SERVICE BULLETIN

APPLICABILITY: 2013-14MY Legacy & Outback Models
 with 2.5L FB Engine

NUMBER: 02-150-14R

SUBJECT: Revised Valve Train Parts to Reduce a Warm
 Engine Tapping Sound from the Left Cylinder Head

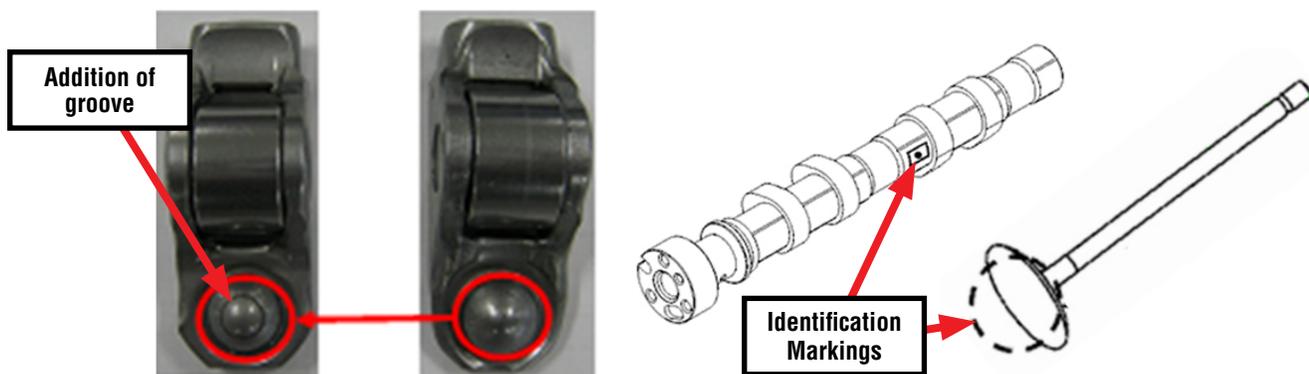
- Design change to the valve rockers
- Camshaft profile change
- 1.65mm longer intake and 2.4mm longer exhaust valve stem lengths

The illustrations below show additional information about the changes to the valve rockers, camshafts and valves to help readily distinguish them from the previous version parts.
